Model: Finisher Adapter Type C	Date: 15-Nov-07	No.: RD375001a
--------------------------------	-----------------	----------------

Subject: Firmware Release Note: Finisher Adapter Type C		Prepared by: T. Toriumi	
From: 2nd Tech. Support Sec. Service Support Dept.			
Classification:	<input type="checkbox"/> Troubleshooting	<input type="checkbox"/> Part information	<input type="checkbox"/> Action required
	<input type="checkbox"/> Mechanical	<input type="checkbox"/> Electrical	<input type="checkbox"/> Service manual revision
	<input type="checkbox"/> Paper path	<input type="checkbox"/> Transmit/receive	<input type="checkbox"/> Retrofit information
	<input checked="" type="checkbox"/> Other ()

Subject: Important note for harness position

Important Note about the Harness Position When Installing the Finisher Adapter Type C (D375)

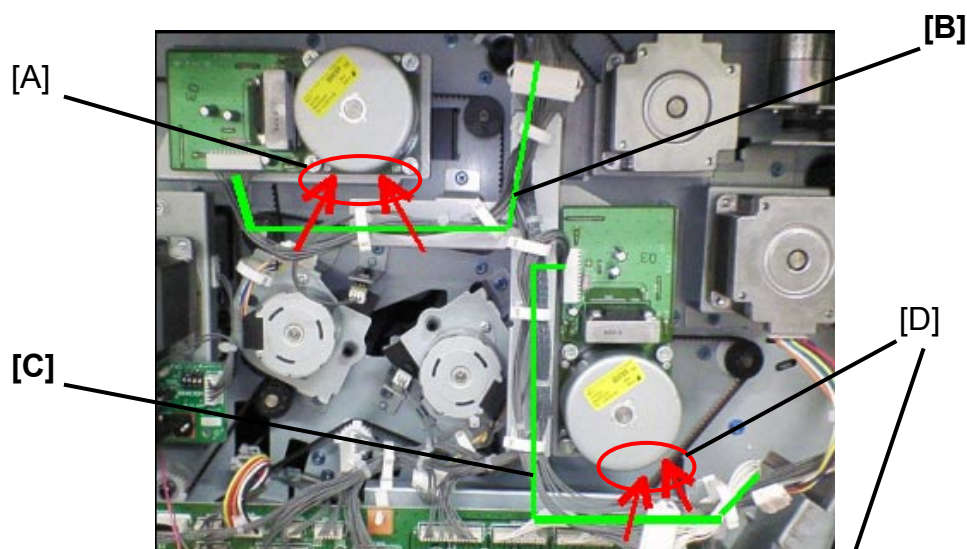
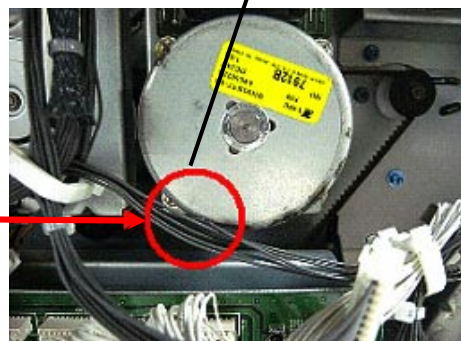
When you attach the Finisher Adapter D375 to the Finisher SR5000, make sure to route the harness **along lines [B] and [C]** in the photo. If you do not, the harness may touch the motors ([A] and [D]), which can damage or even disconnect the harness.

The harness is touching the motor.

- **Add** the following important note:
